GW - 001

**GENERAL
CORRESPONDENCE**

RE: Discharge Plan GW-1
Bloomfield Refinery

RESPONSE TO NMOCD COMMENTS OF APRIL 29, 1988
ON BLOOMFIELD REFINERY DISCHARGE PLAN

TYPICAL BERM SOUTH REFINERY AREA

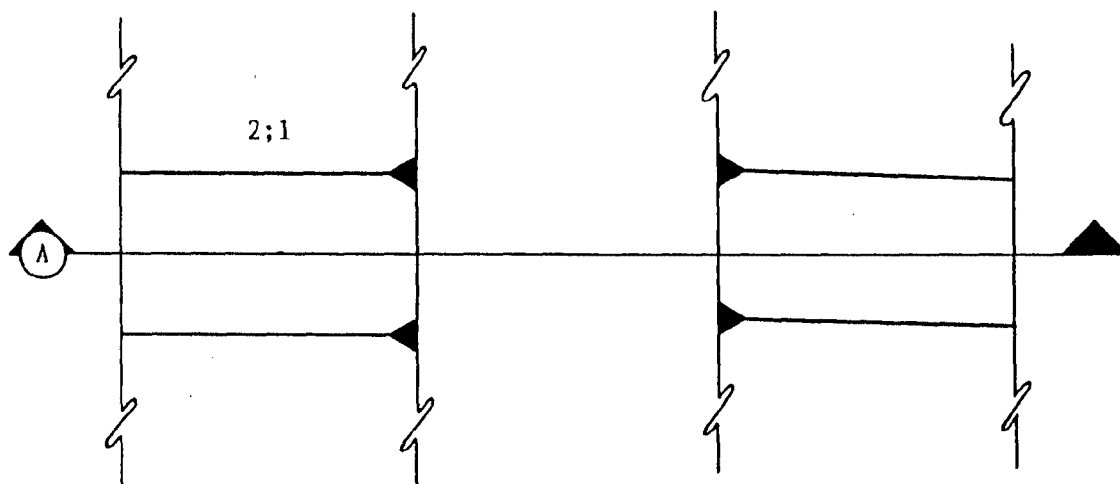
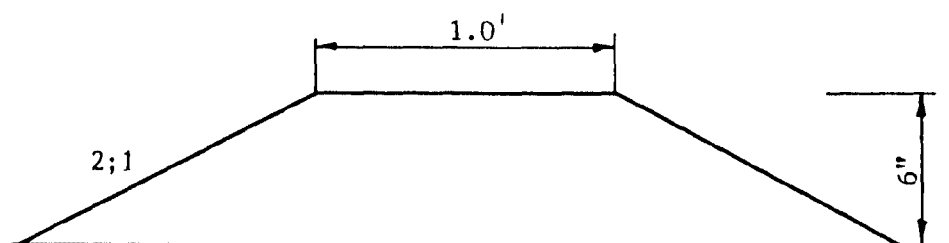
2. As stated in the Discharge Plan, the first controlled flooding land applications would be for the purpose of conducting a field test of the system. Eighteen inches of treated water would be applied to the site over a 5-day period. Every 2 weeks after the application, water levels, product thickness and specific conductance would be monitored in the recovery wells and the following monitor wells: GBR 5, 7, 13 and 20. If no response was observed after one month of observation, a second application of 36 inches would be conducted and monitored as described above. If required, a third application of 54 inches over a 10-day period would be conducted. The monitoring data from the test applications would be evaluated and a final proposal for application in this area would be submitted to NMOCD. It should be noted that a response is anticipated if 36 inches are applied over a 5-day period. Attachment #1 shows the redesign for the berm to be constructed in connection with the land application site.

WATER TABLE IN SEPTEMBER, 1987

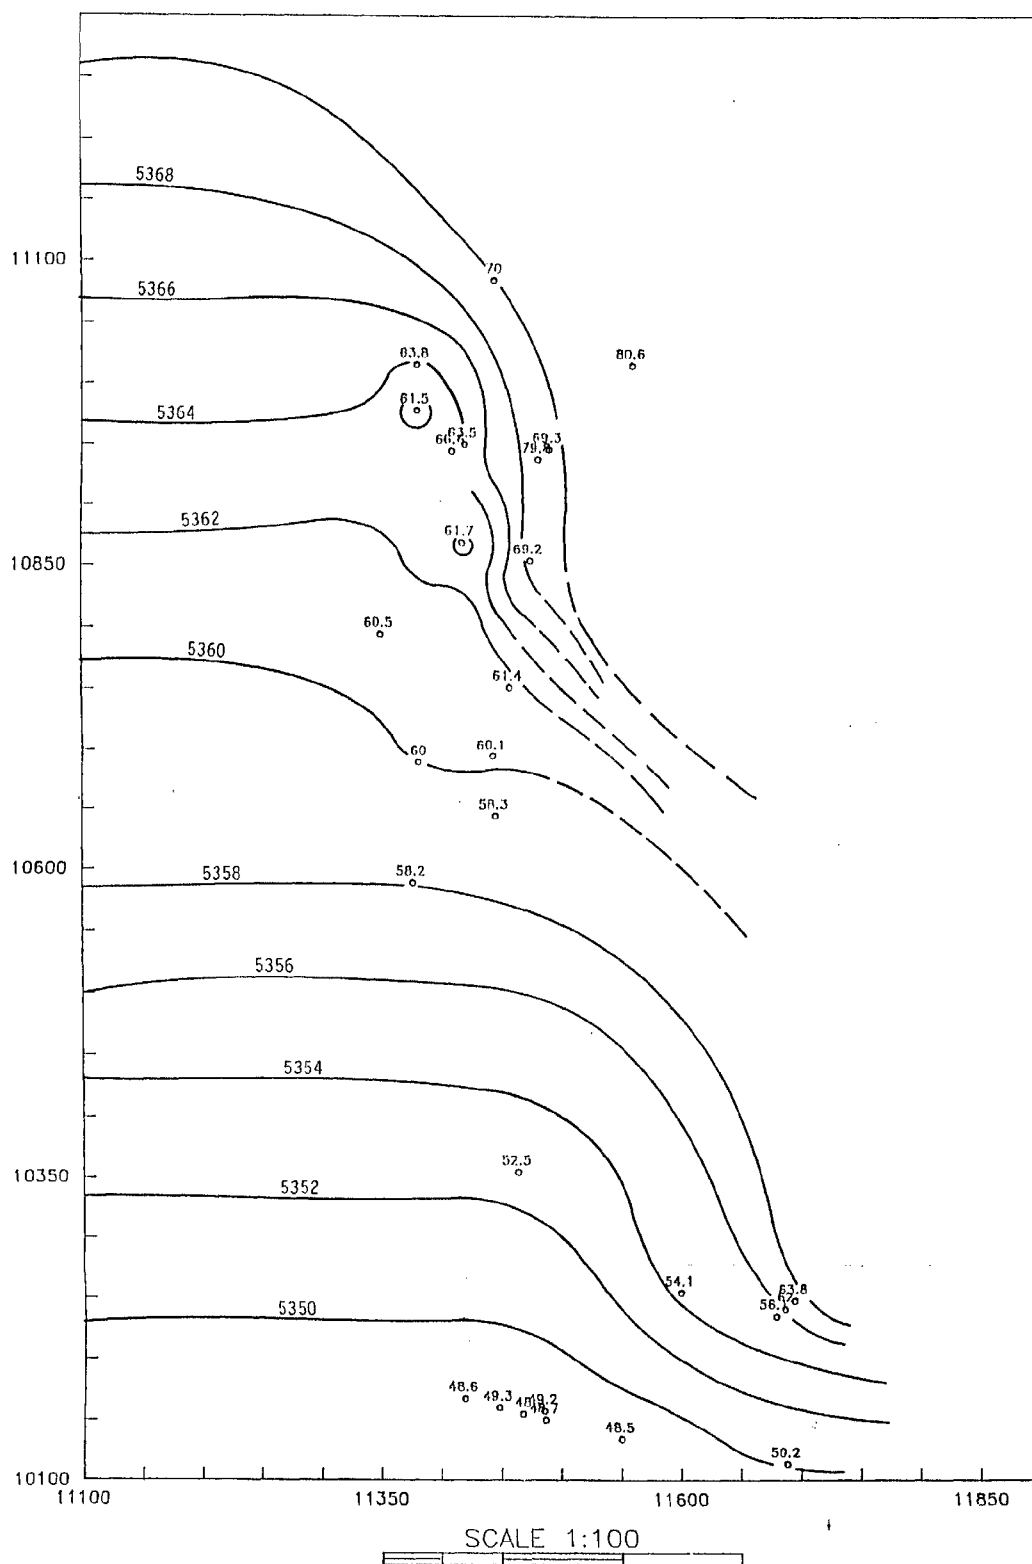
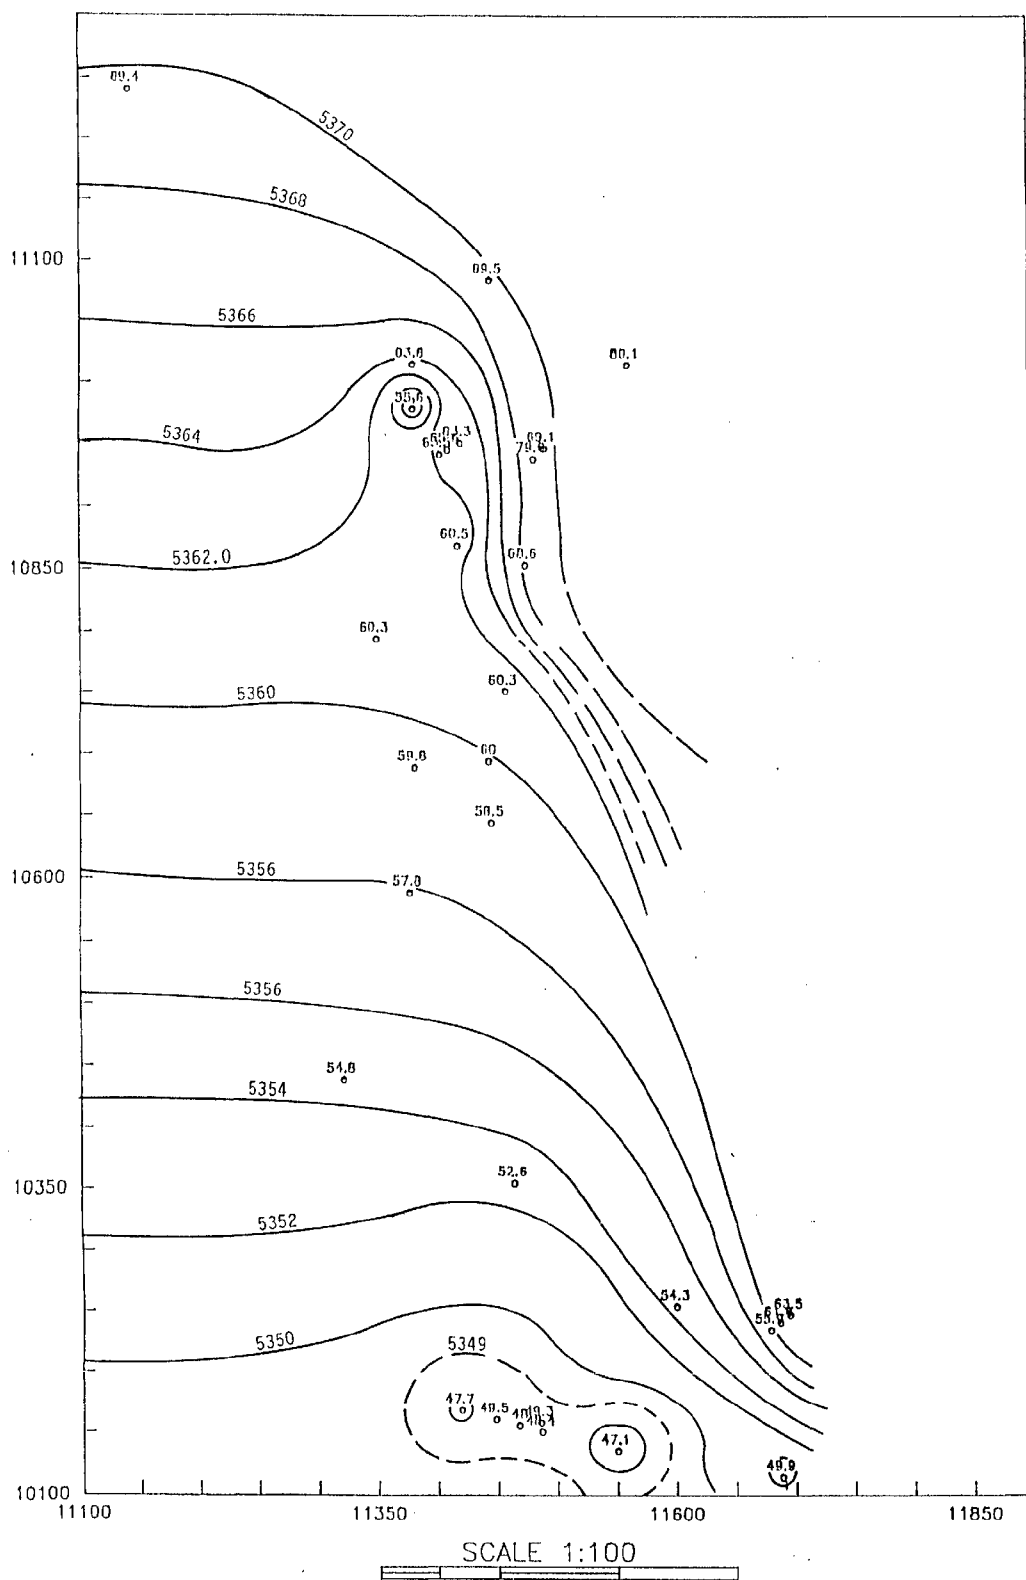
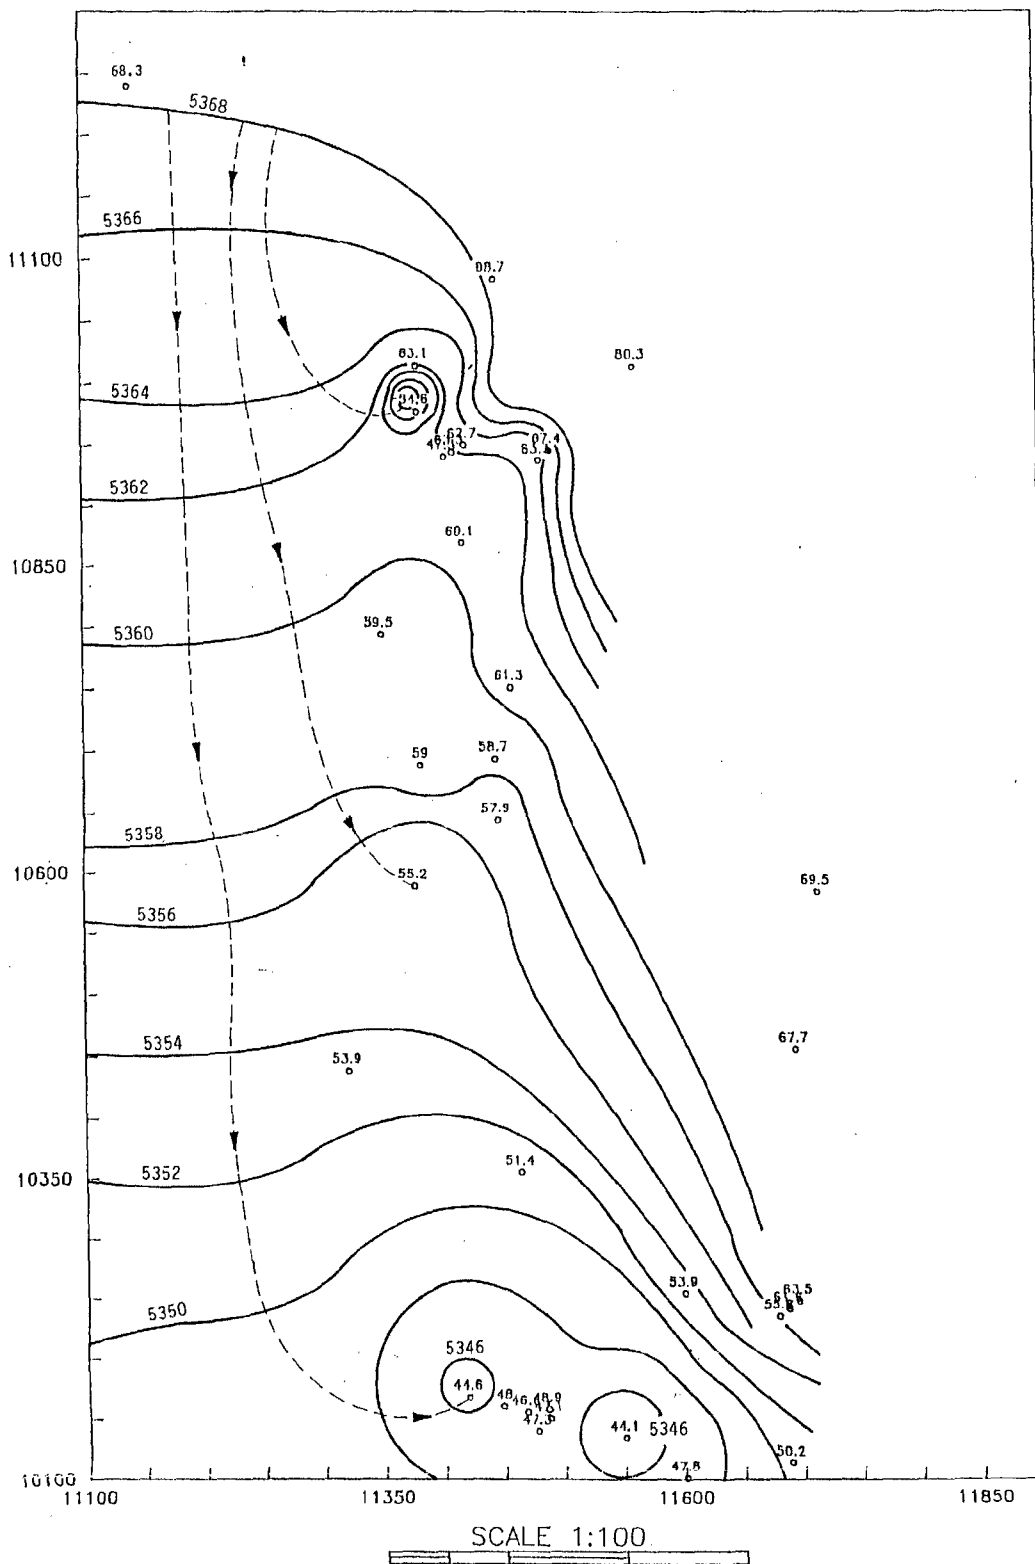
The enclosed ground water elevation maps (Attachment #2) were constructed from recent data and show that the system is operating as predicted. Best professional judgement was employed in areas of closely-spaced data. Not all data points were utilized in the construction of the map. A data point was not employed if it was determined that the well measured a perched water table (GBR-23) or if the well was not deep enough (GBR-10). All of the data from which these maps were based are included in Attachment #3.

The water table elevation maps show that the recovery system is working as predicted. The hydrocarbons released by the refinery are being effectively captured by the recovery wells. Accordingly, GCL does not believe that additional work on model review is warranted.
